**ADDENDUM 01 TO THE
CONTRACT DOCUMENTS**

**COTE BLANCHE BAY HYDROLOGIC RESTORATION
PVC WALL EXTENSION PROJECT
(TV-04)**

ST. MARY PARISH, LOUISIANA

**LOUISIANA
COASTAL PROTECTION AND RESTORATION
AUTHORITY
OPERATIONS BRANCH**

SHEET 2 OF 9

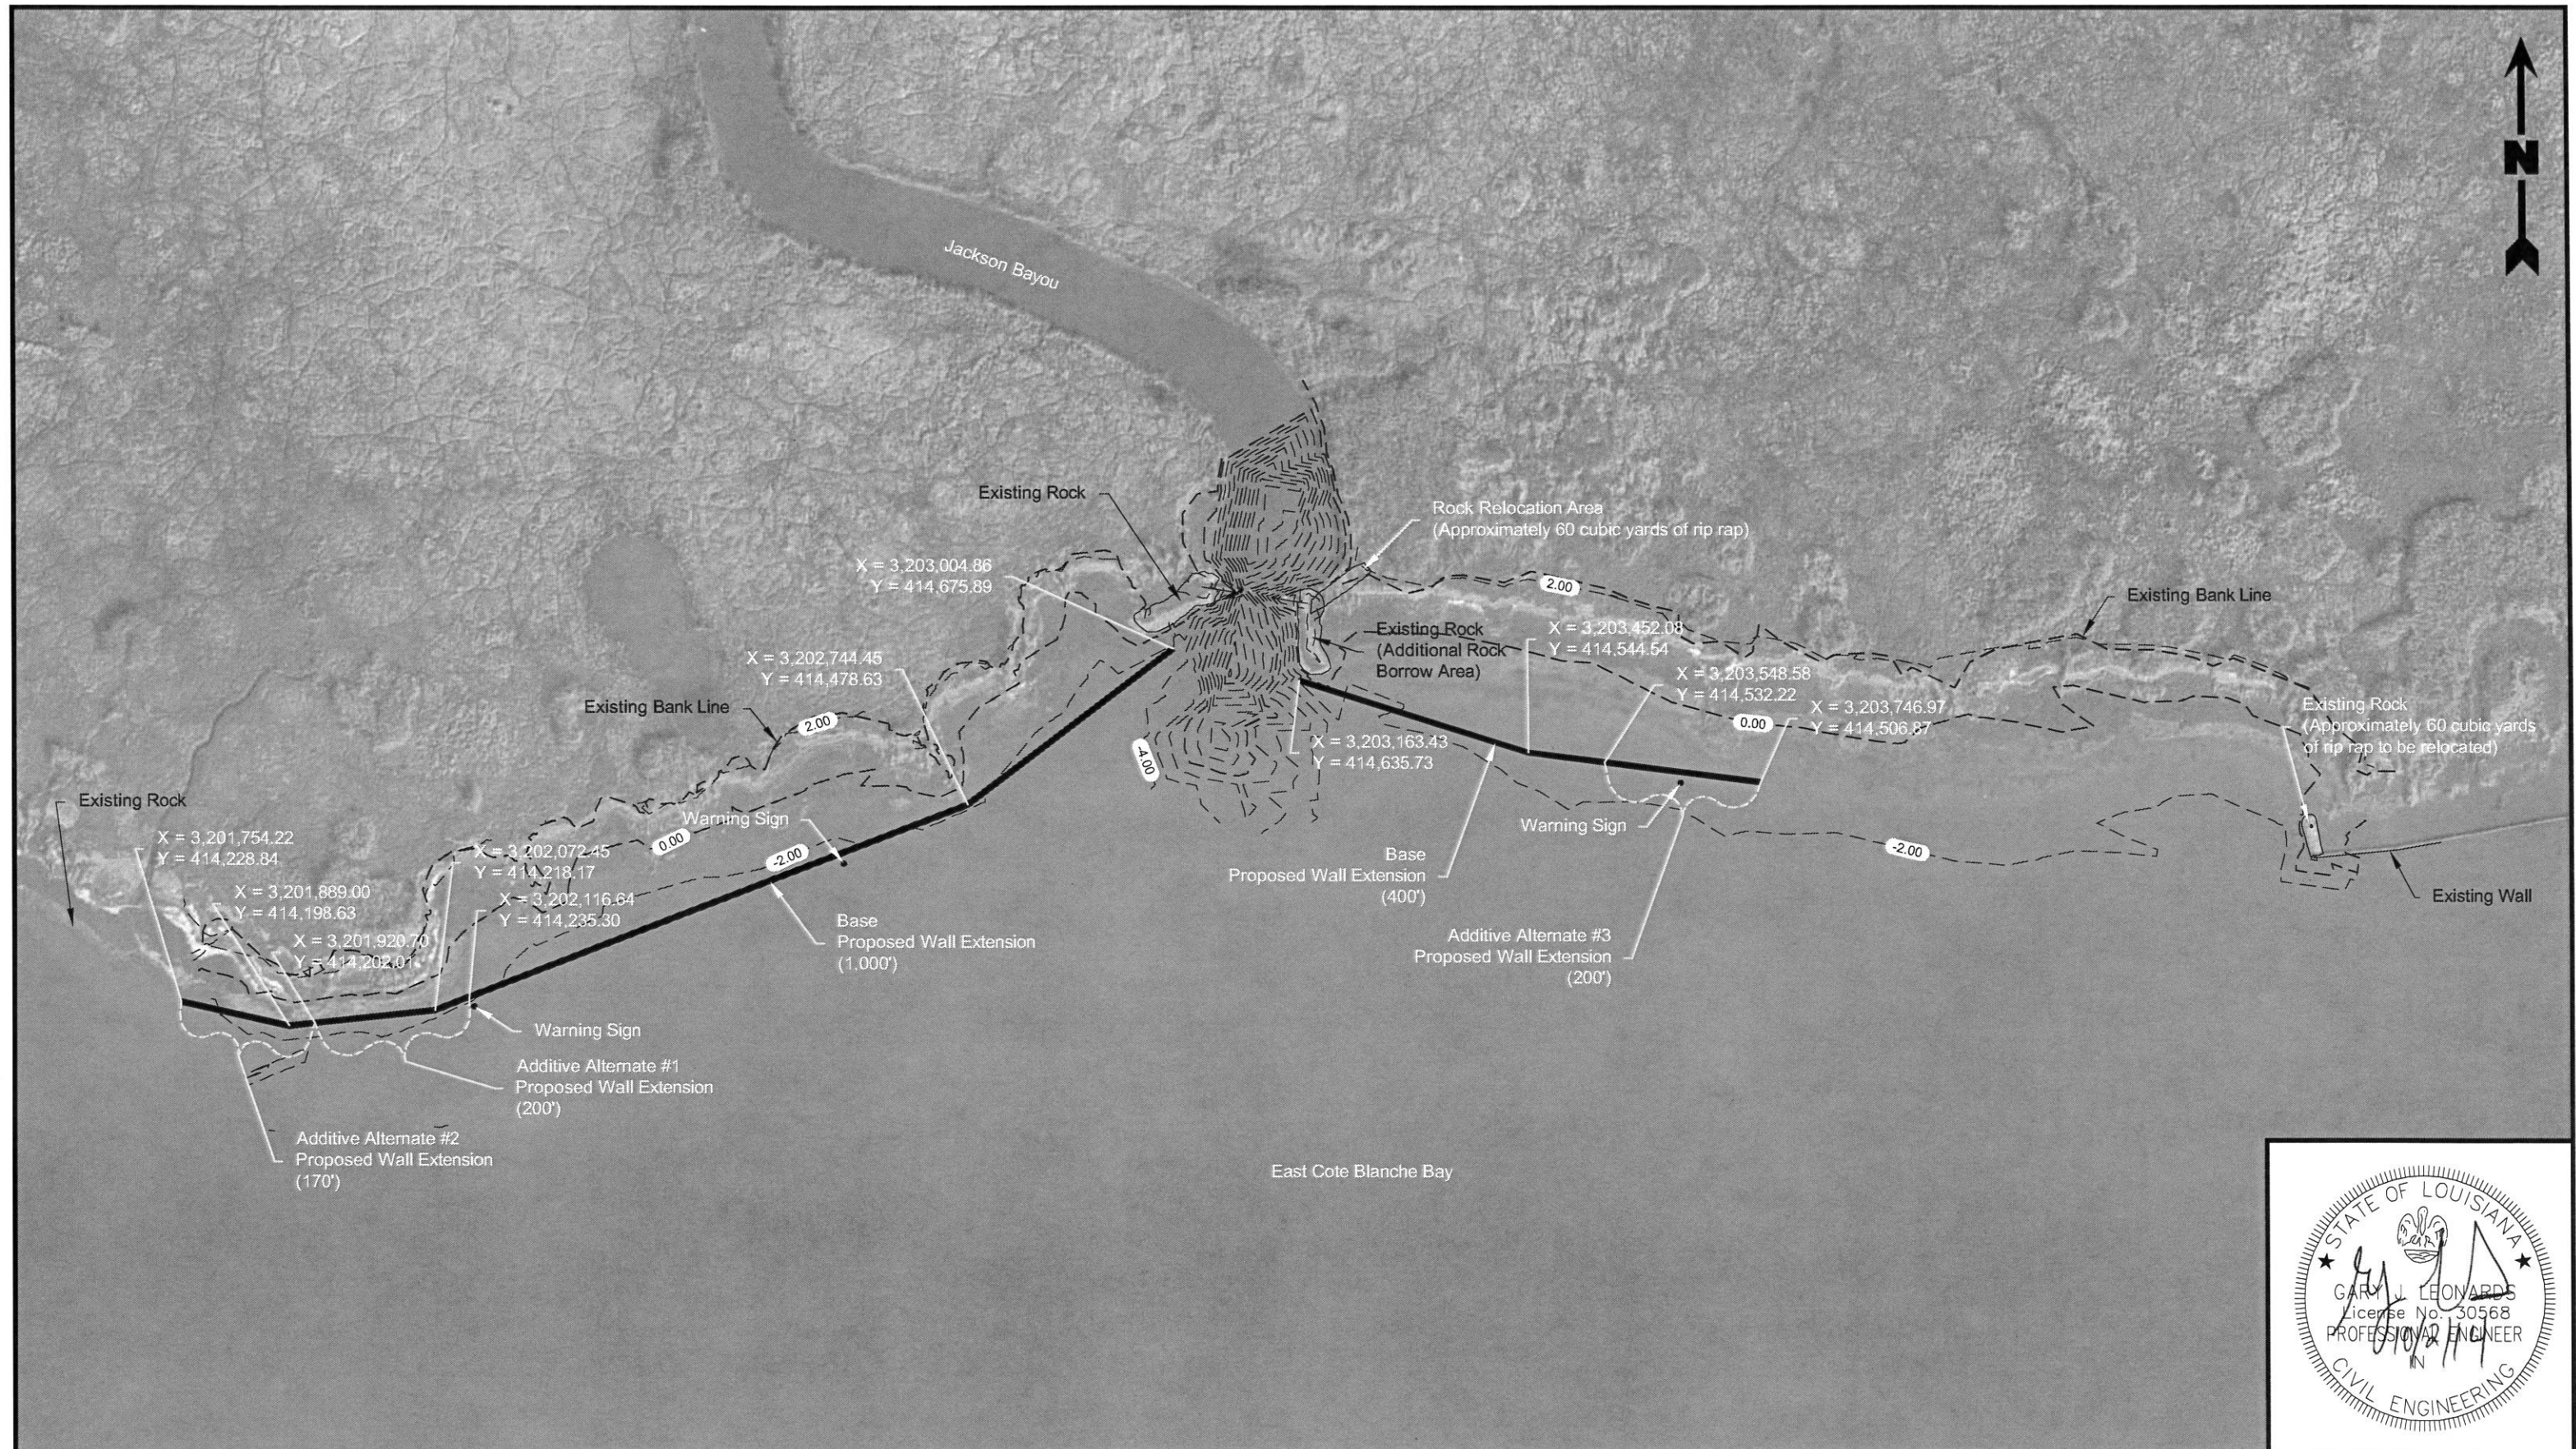
The complete set of construction drawings for this project is included in Attachment 4. The title sheet has been updated, the summary of estimated quantities has been updated on Sheet 2, an additional source of rock has been added to Sheet 4, and Sheets 7, 8, and 9 are new sheets.

REV.	DATE	DESCRIPTION	BY
1	10/2/14	Updated Quantities and Number of Sheets	LMH

SHEET 7 OF 9

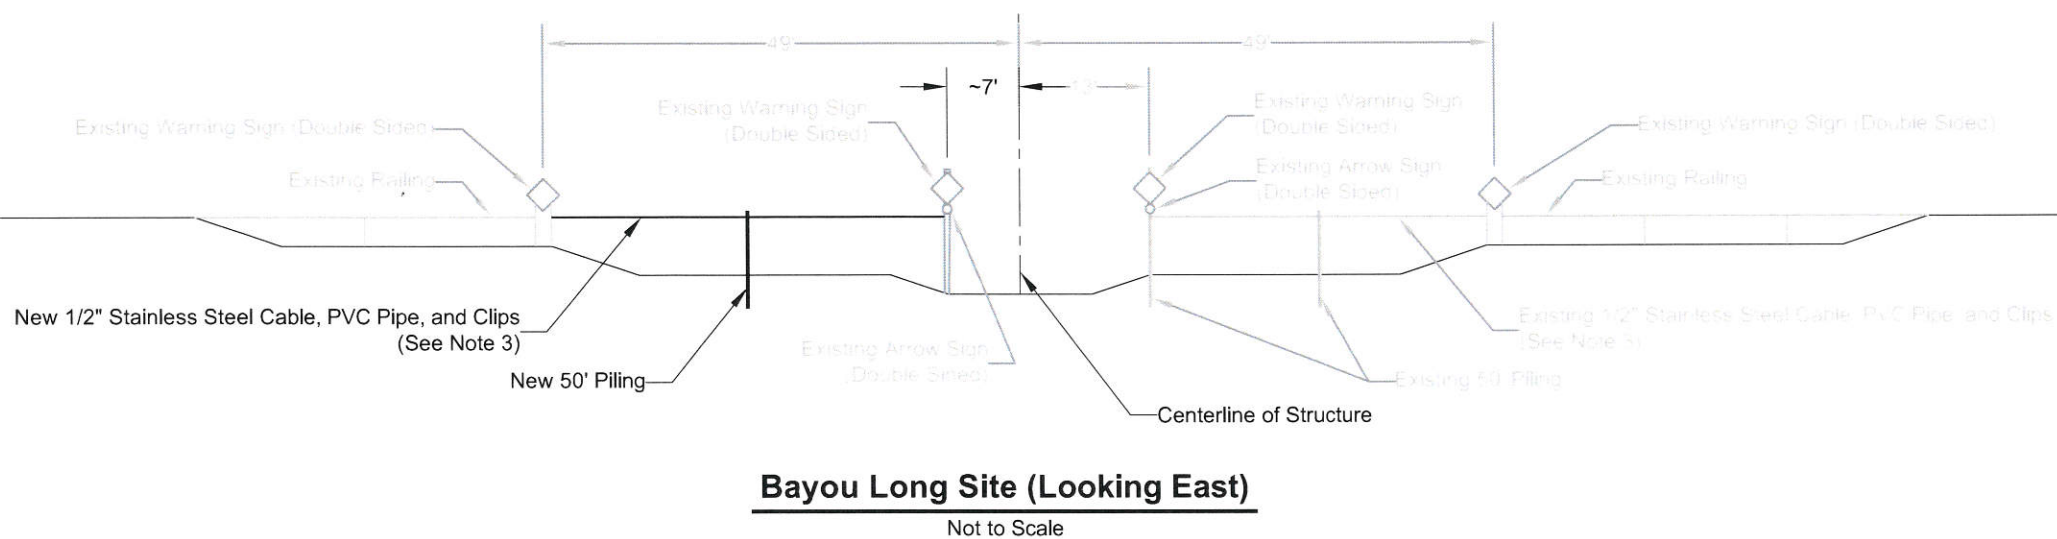
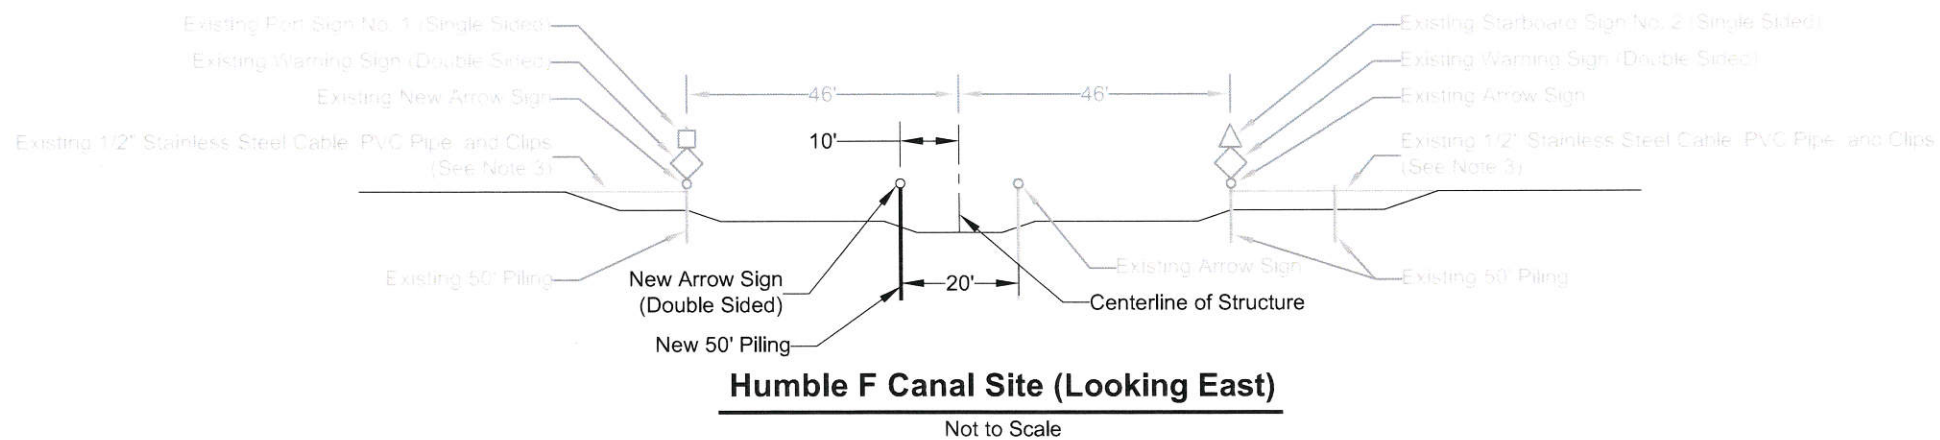
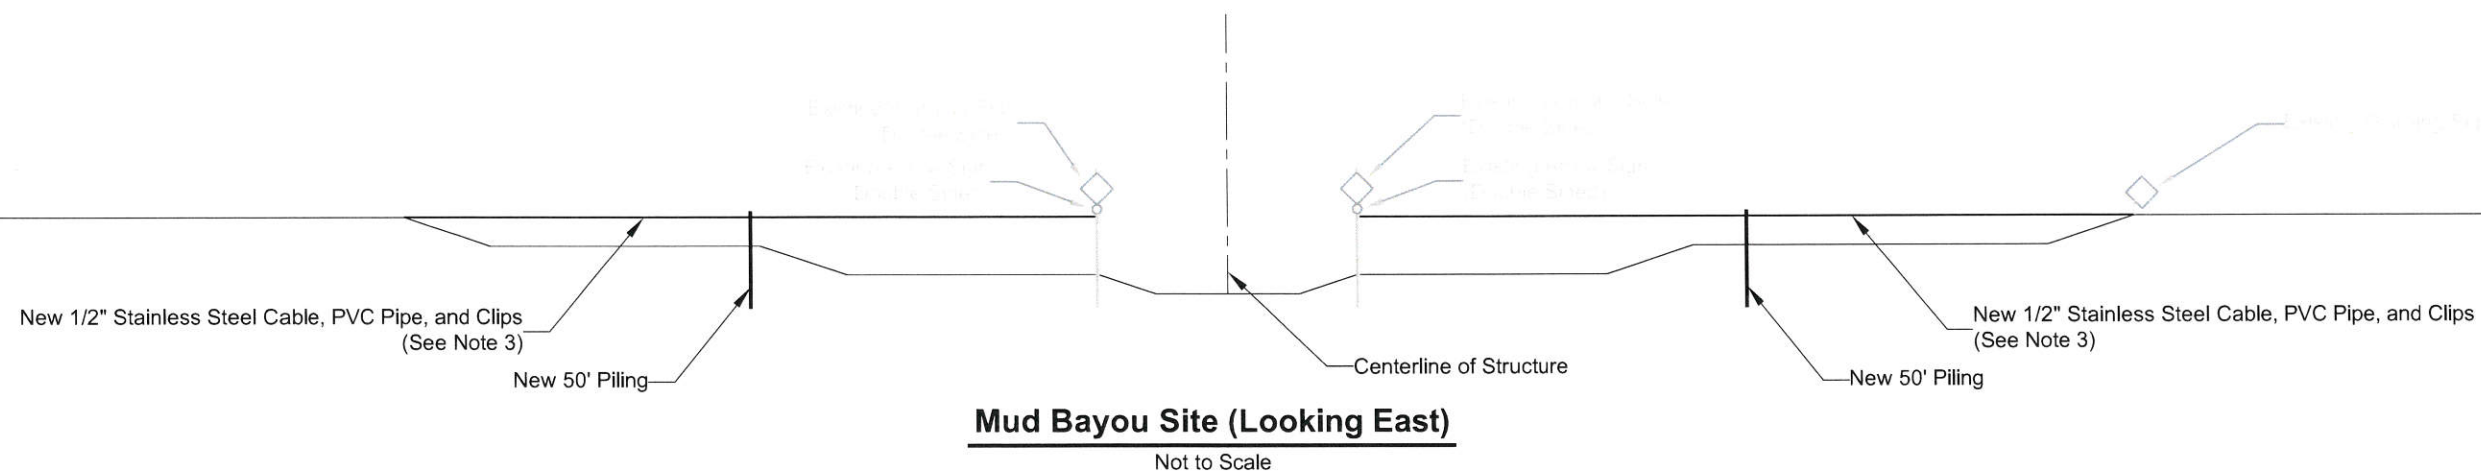
901.1 Scope: The contractor shall furnish all of the materials, labor and equipment necessary to re-install the rail components on the weir structure at the mouth of Mud Bayou, on one side of the weir structure at Bayou Long, and install a timber pile and arrow sign at Humble F Canal in accordance with the Plans and these Specifications, or as directed by the Engineer.

SHEET 8 OF 9

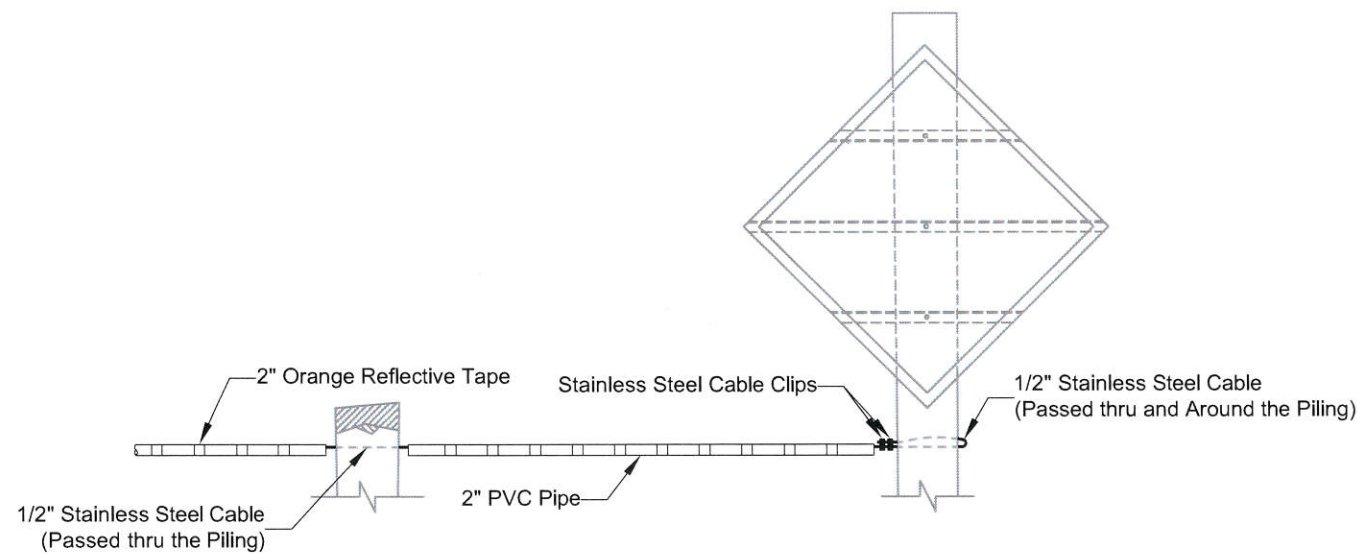
1. Sheet piling and fill material not shown for clarity.
2. Pile cap is continuous to wing-wall. Covering the entire wing-wall.
3. Stainless Steel Cable is at a constant elevation, consistent with the elevation at the intersection of railing and pile cap.

901.2 Fabrication: The replacement rails shall be installed using a ½ inch diameter stainless steel cable that will be secured to the existing sheet pile wall on one end and the existing wooden pile on the other end. Stainless steel cable clips shall be used to secure the cable. The stainless steel cable shall be inserted through a two inch diameter, schedule 40 PVC pipe and wrapped in red reflective tape as shown on the Plans. The remnants of the existing pipe rails shall be removed prior to the installation of the new cable rails and disposed of by the contractor.

901.3 Installation: The installation of the new railings on the structures in Mud Bayou and Bayou long will require the installation of treated timber piles to support the cable structure. These shall be installed with the use of a track hoe or other suitable pile driving equipment. The top of these new pilings shall be one foot above the elevation of the existing sheet pile structure at each of these locations. Two pilings will be required at the Mud Bayou structure, one piling will be required at the Bayou Long structure, and one piling will be required at the Humble F Canal. An arrow sign, as shown on the Plans, will be installed on the piling at the Humble F canal. The sign shall be bolted to the new timber piling. After completion of the pile, sign installation, and cable rail installation, the tops of the timber piles shall be trimmed to remove any sharp or jagged edges and covered with a piece of galvanized aluminum flashing as shown on the Plans.
